**REMARKS**

The Office Action dated December 1, 2005 has been reviewed carefully and a Request for Continued Examination is being filed herewith with the present amendment.

FIG. 4

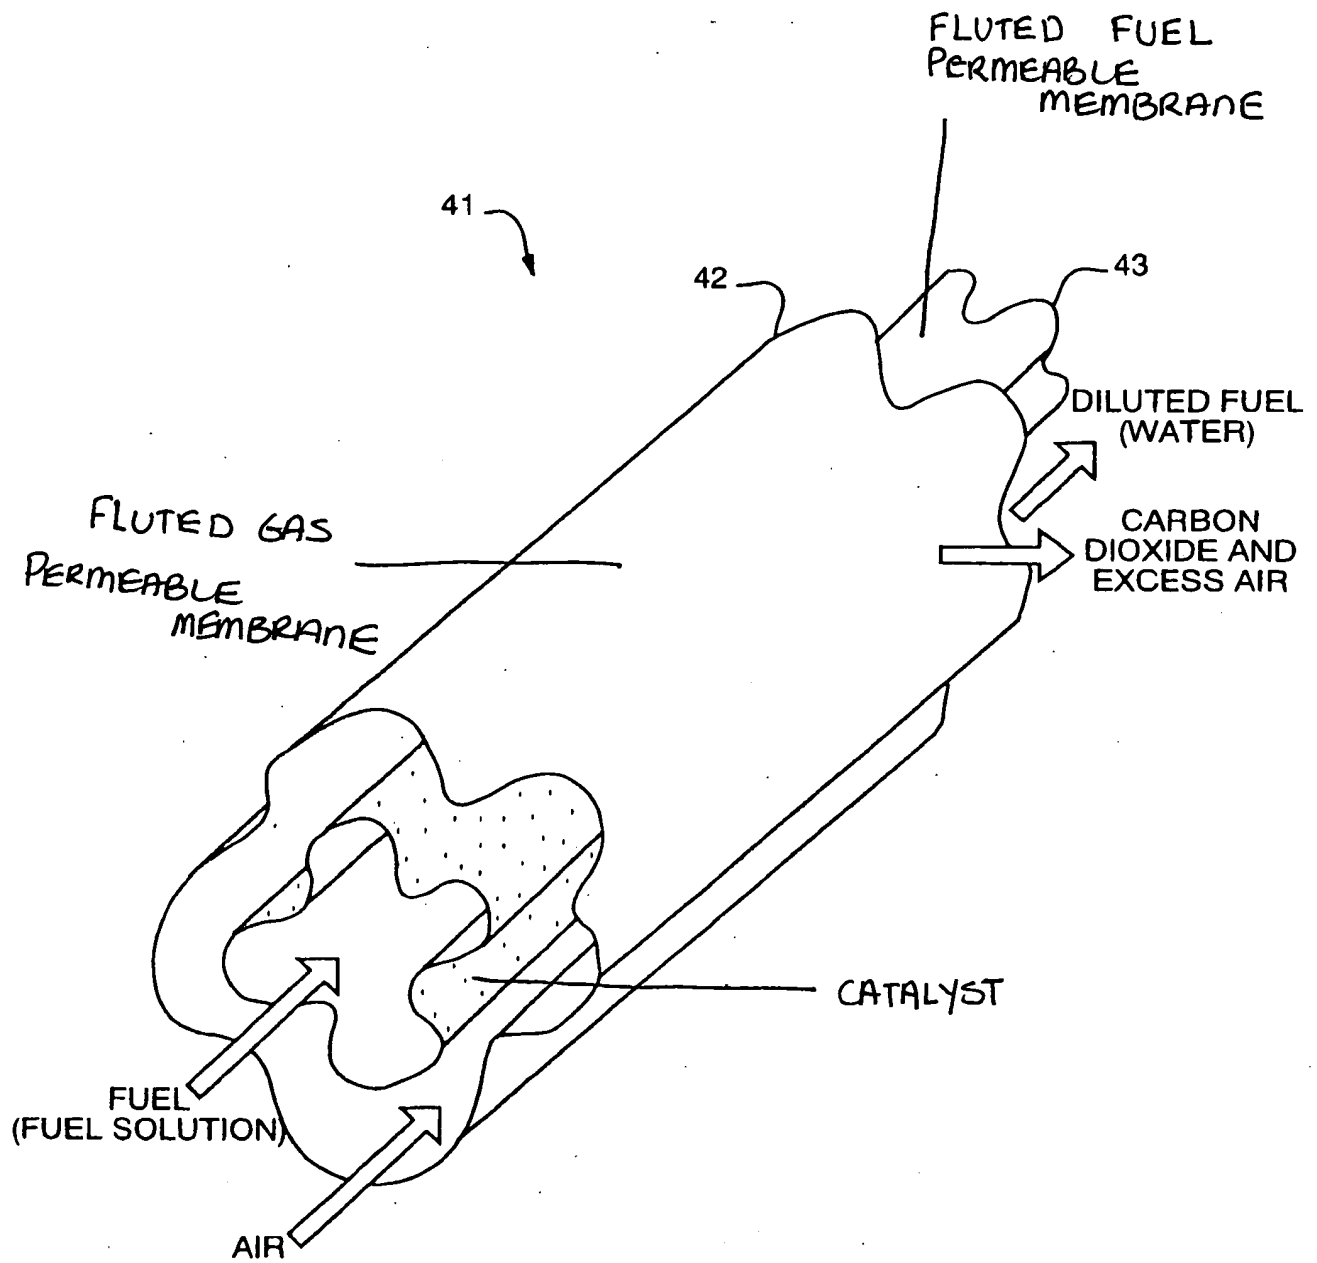
Replacement sheets containing the corrected drawing figures for Fig. 4 and Fig. 6 as well as a marked-up copy of each replacement sheet are being submitted herewith for the approval of the Examiner.
